SUBJECT: Report on Project Assessment of the Erbil City Transformers, Erbil, Iraq (Report Number SIGIR-PA-06-037)

**SIGIR PA-06-037**

## Erbil City Transformers Erbil, Iraq

Site Photo 5: 11kV and 400V/230V conductors positioned on 11 m pole

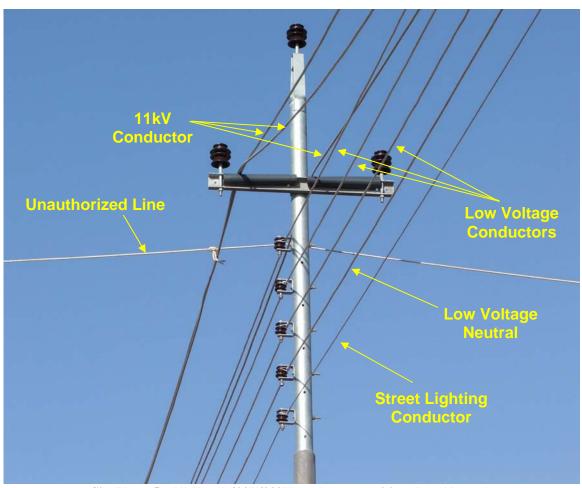
Site Photo 5 shows one of the 11 m poles carrying medium voltage (11kV) and low voltage (400V/230V) conductors. The conductors had been strung, but were not sagged or secured to the insulators. For securing the conductors, the design called for four low voltage insulators mounted to the pole using D-brackets, and three 11kV pin insulators (two mounted on each side of a cross arm and one at the pole cap). The insulators and assembly components, as installed, appeared to meet the requirements of the design.

Also shown in Site Photo 5 is an illegal power tap run from across the street or from a neighborhood generator. It has nothing to do with the Erbil City Transformer project. Someone in the local area is taking advantage of the newly installed poles to run their unauthorized line across the street. Based on discussions with USACE RE, these illegal taps regularly occur. However prior to turnover of the project, the unauthorized line will be removed.

Site Photo 8. H-Pole with connection s to 11kV and low voltage conductors Photo provided by USACE

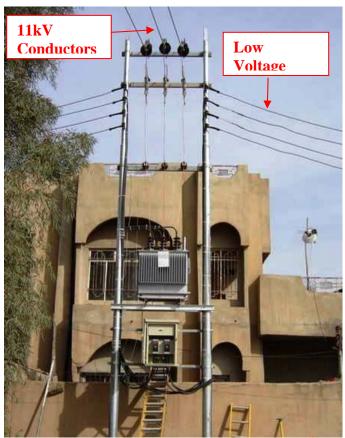
Site Photo 8 shows a complete installation of the transformer, an open low voltage distribution panel (with two main circuit breakers), fuse cutouts<sup>4</sup>, and insulators on the H-pole as well as the medium voltage conductors connected to the high side of the transformer and the low voltage conductors on each side of the H-pole.
